**DISTRICT OF SAANICH**

**Report To:** MAYOR AND COUNCIL  
**Date:** MAY 1, 2009  
**From:** RUSS FUOCO, DIRECTOR OF PLANNING  
**Subject:** REZONING, SUBDIVISION & DEVELOPMENT VARIANCE PERMIT APPLICATIONS. REQUEST TO WAIVE THE 10% PERIMETER ROAD FRONTAGE REQUIREMENT  
FILES: SUB00588; REZ00433; DVP00267

**Address:** 1420 Simon Road

# Memo

Figure 1. Proposed Site Plan

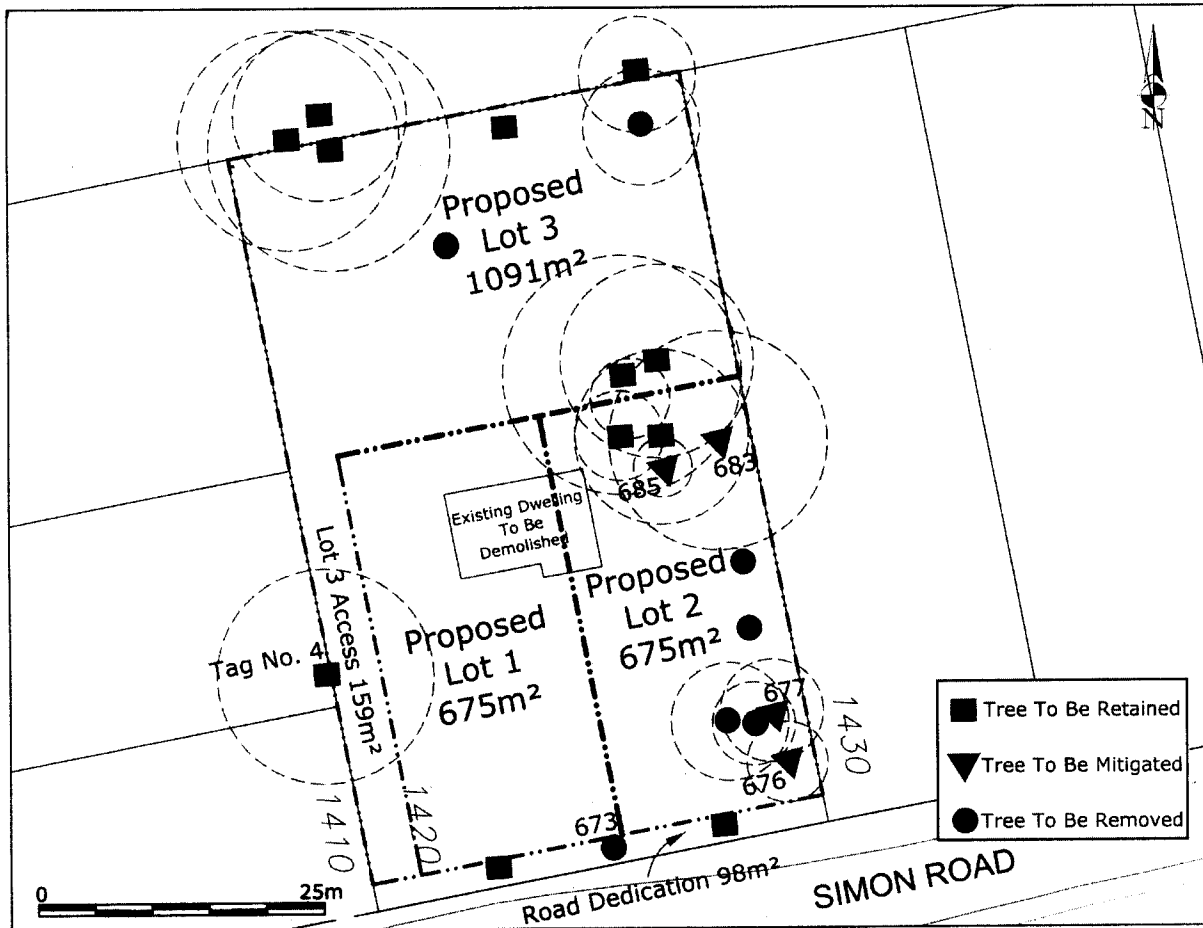
To optimize retention the report recommends using a “floating” driveway system over the root zone as well as relocating required servicing between proposed Lots 1 and 2 to minimize impacts on the large Garry oak #4 adjacent to the proposed panhandle lot. The report also recommends reducing the size of the potential building envelope of proposed Lot 2 to be outside the Critical Root Zone of Garry oak #683. This should also result in the retention of tree # 685.

The young Chestnut trees fronting the road will become boulevard trees and will be protected through the development process. Tree #673 will be removed to accommodate servicing and to preserve Tree # 4 because it is more worthy of retention.

Braefoot Action Plan Development Guideline G4 recommends decreasing the amount of impervious areas. Requiring proposed Lot 1 to access from the panhandle would eliminate one driveway. The driveway for Proposed Lot 2 should be located near the westerly lot boundary to avoid the root zones of Tree # 676 & 675 and consideration should be for a single width driveway within the boulevard area.

- Provision of suitable tree preservation covenants;
- Driveway construction in accordance with consulting arborist recommendations;
- Provision of suitable covenants and reciprocal easements to provide one shared access for proposed Lots 1 and 3.

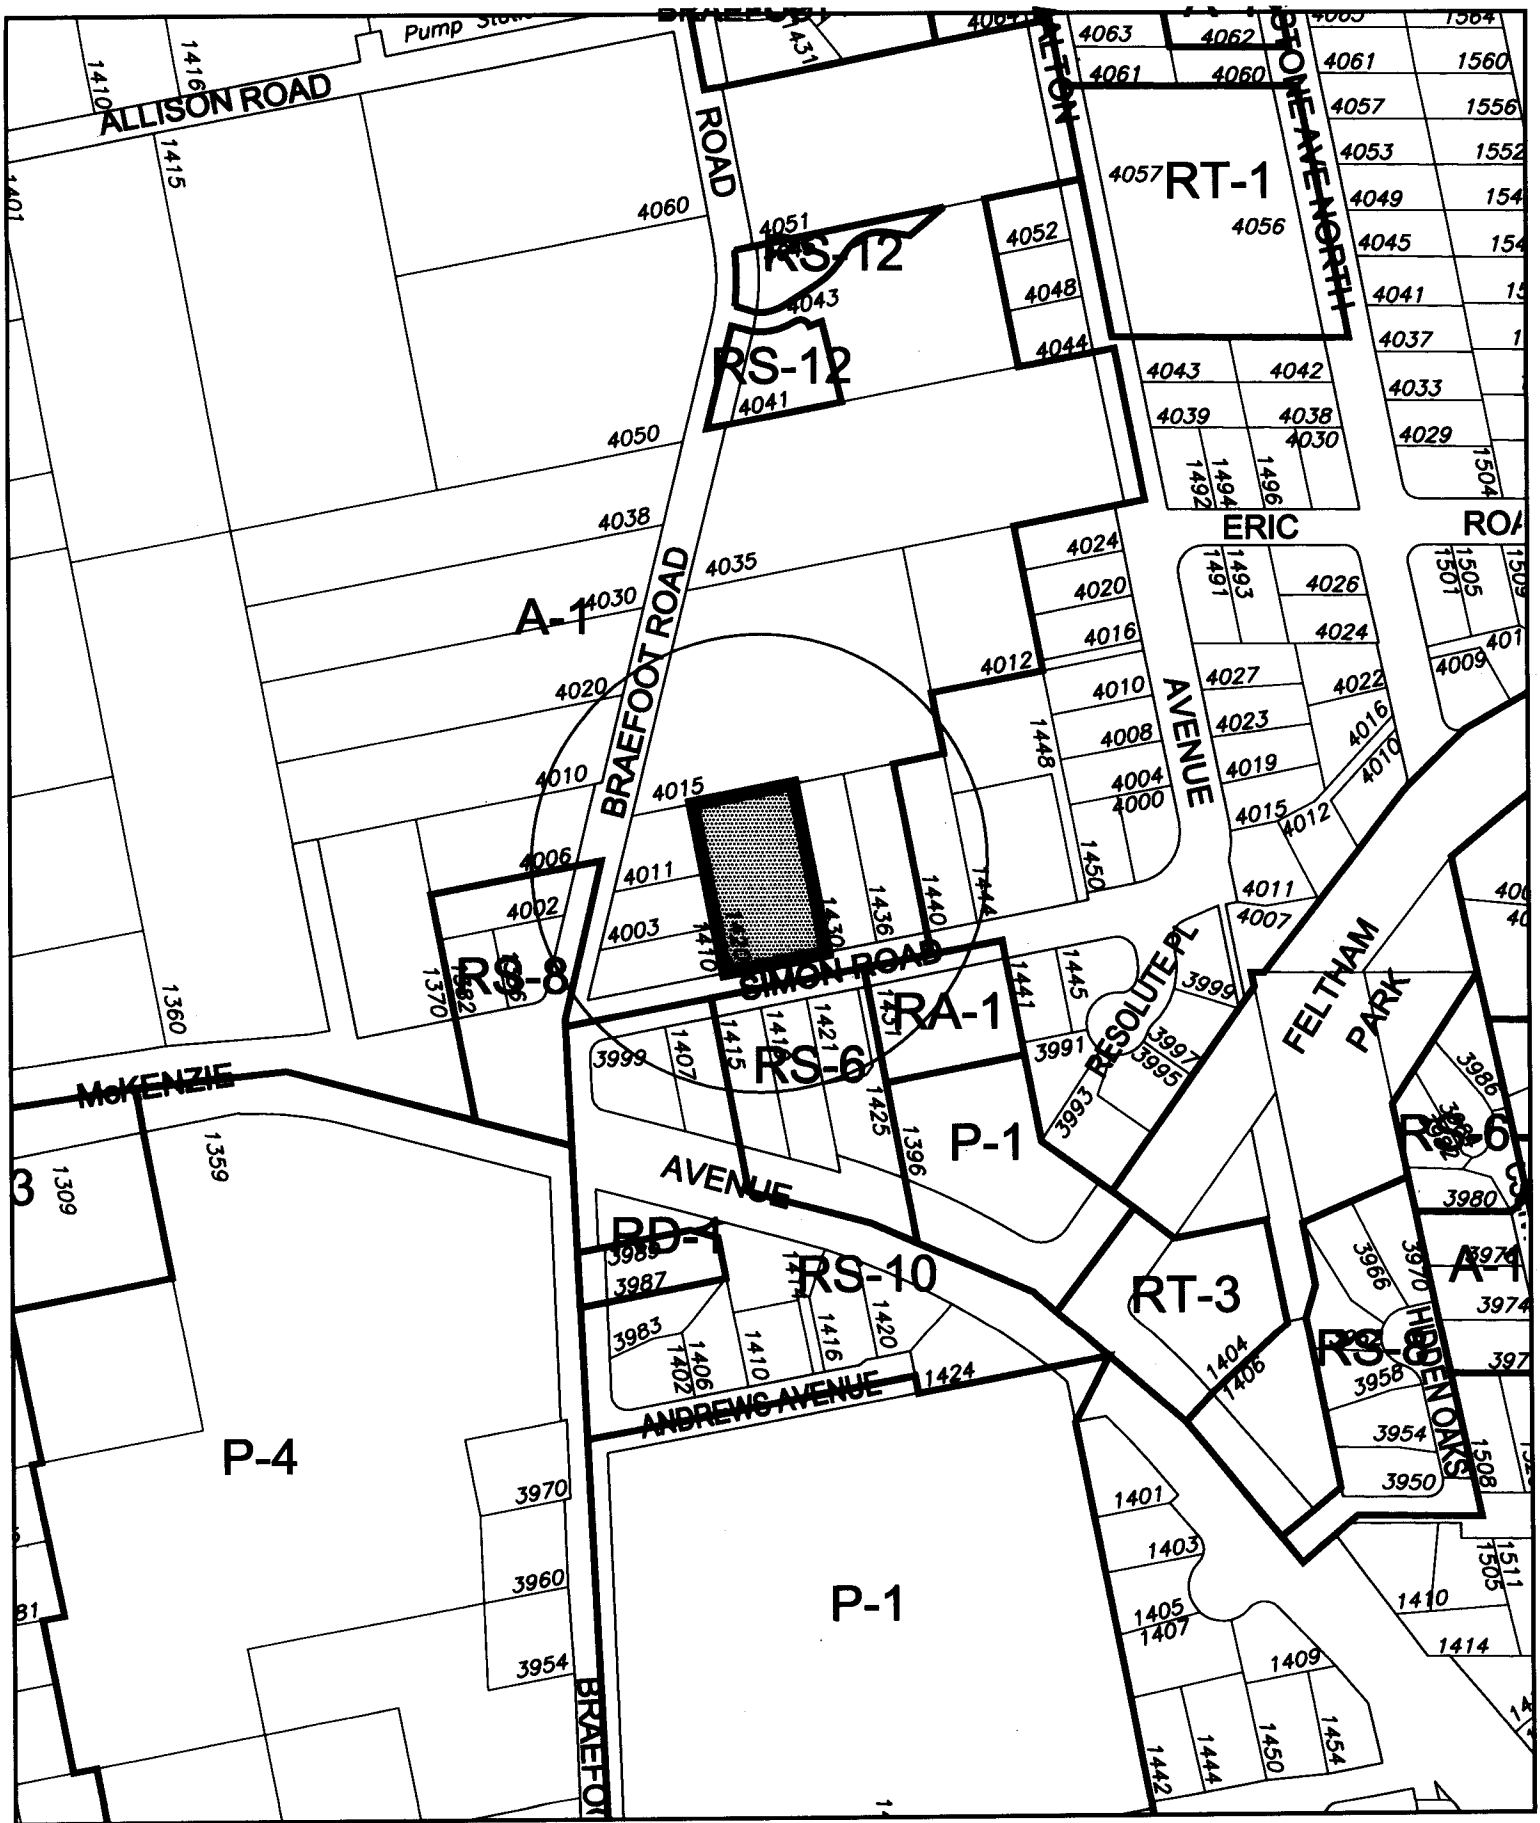
DRAIN - 1. THE EXISTING DRAIN CONNECTION IS TO BE EXTENDED TO THE NEW PROPERTY LINE TO SERVE PROPOSED LOT 1.

DRAIN - 3. SUBSEQUENT DRAIN CONNECTIONS WILL BE REQUIRED FOR PROPOSED LOTS 2 AND 3 FROM THE EXISTING MAIN ON SIMON ROAD.

HYDRO - 1. UNDERGROUND WIRING IS REQUIRED TO SERVE PROPOSED LOT 3.

ROAD - 1. 2.44 M WIDE PROPERTY DEDICATION IS REQUIRED ALONG THE ENTIRE FRONTAGE OF THE SUBDIVISION ON SIMON ROAD FOR ROAD ALLOWANCE.

ROAD - 3. THE EXISTING CONCRETE CURB AND GUTTER ON SIMON ROAD, NEAR THE SOUTHWEST CORNER, MUST BE EXTENDED ACROSS THE FRONTAGE OF THIS SUBDIVISION.

SEWER - 1. THE EXISTING SEWER CONNECTION ON SIMON ROAD MUST BE EXTENDED TO THE NEW PROPERTY LINE TO SERVE PROPOSED LOT 3.

SEWER - 2. SUBSEQUENT SEWER CONNECTIONS WILL BE REQUIRED FOR PROPOSED LOTS 1 AND 2 FROM THE EXISTING MAIN ON SIMON ROAD.

WATER - 1. PROVISIONAL WATER CONNECTIONS WILL BE REQUIRED FOR PROPOSED LOTS 2 AND 3..

WATER - 2. THE EXISTING 13MM WATER SERVICE TO PROPOSED LOT 1, MUST BE UPGRADED TO 19MM.
